Acme Ozone - Initial Feedback/Comments

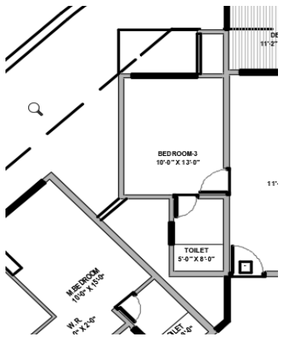
4 about 4m cantilver with 1m backs span not recommended
Transfer girder at stilt level is possible but not preferred.

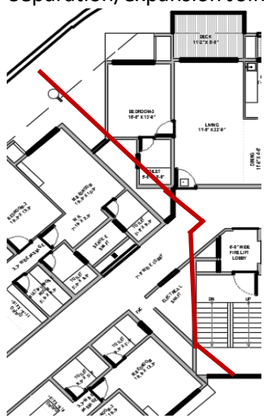
Separation/expansion Joint is mandatory
